| Well Name: MULE 11-14 FED COM | Well Location: T25S / R31E / SEC 11 / NENE / 32.150873 / -103.743227 | County or Parish/State: EDDY / NM |

Notice of Intent

Sundry ID: 2791639

| Type of Submission: Notice of Intent | Type of Action: APD Change |

WELL LOCATION AND ACREAGE DEDICATION PLAT

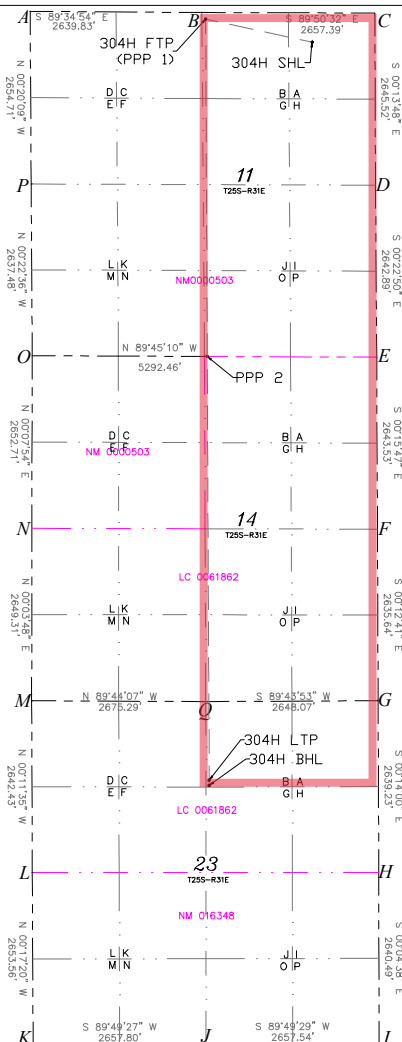
Permitted Well name: MULE 11-14 FED COM 525H
Proposed Well name: MULE 11-23 FED COM 304H
Permitted BHL: SWSE, 20 FSL, 1350 FEL, 14-25S-31E
Proposed BHL: NWNE, 1288 FNL, 2600 FEL, 14-25S-31E
Permitted TVD/MD: 9140/19363
Proposed TVD/MD: 10475/22226

Section 2 - Blowout Preventer Testing Procedure

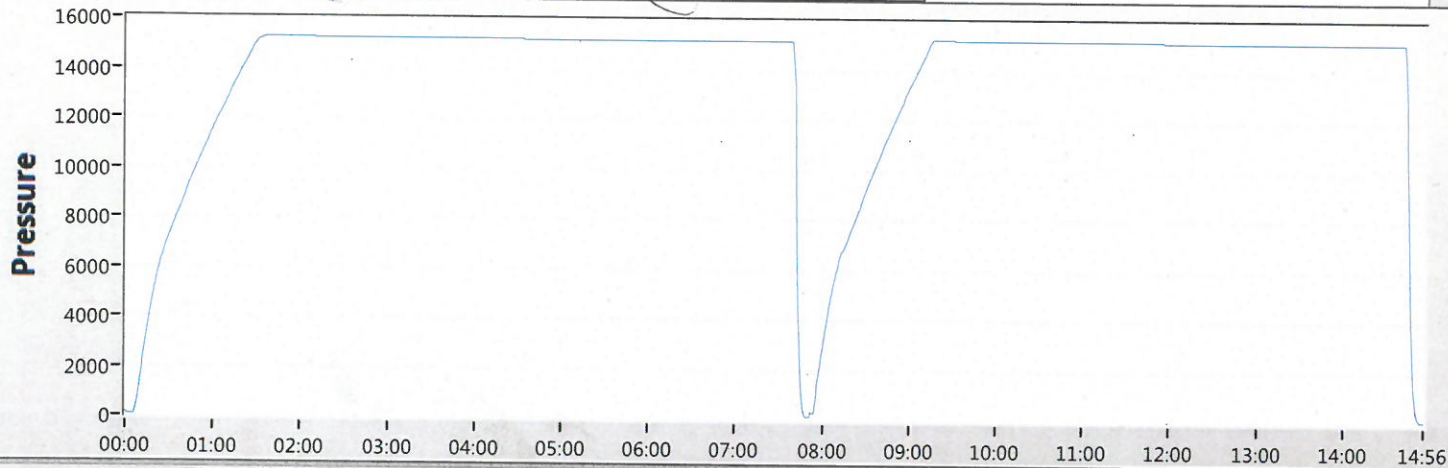
Devon Energy requests to only test BOP connection breaks after drilling out of surface casing and while skidding between wells which conforms to API Standard 53 and industry standards. This test will include the Top Pipe Rams, HCR, Kill Line Check Valve, QDC (quick disconnect to wellhead) and Shell of the 10M BOPE to 5M for 10 minutes. If a break to the flex hose that runs to the choke manifold is required due to repositioning from a skid, the HCR will remain open during the shell test to include that additional break. The variance only pertains to intermediate hole-sections and no deeper than the Bone Springs Formation where 5M BOP tests are required. The initial BOP test will follow 43 CFR 3172, and subsequent tests following a skid will only test connections that are broken. The annular preventer will be tested to 100% working pressure. This variance will meet or exceed 43 CFR 3172 per the following: Devon Energy will perform a full BOP test per 43 CFR 3172 before drilling out of the intermediate casing string(s) and starting the production hole, before starting any hole section that requires a 10M test, before the expiration of the allotted 14-days for 5M intermediate batch drilling or when the drilling rig is fully mobilized to a new well pad, whichever is sooner. We will utilize a 200' TVD tolerance between intermediate shoes as the cutoff for a full BOP test. The BLM will be contacted 4hrs prior to a BOPE test. The BLM will be notified if and when a well control event is encountered. Break test will be a 14 day interval and not a 30 day full BOPE test interval. If in the event break testing is not utilized, then a full BOPE test would be conducted.
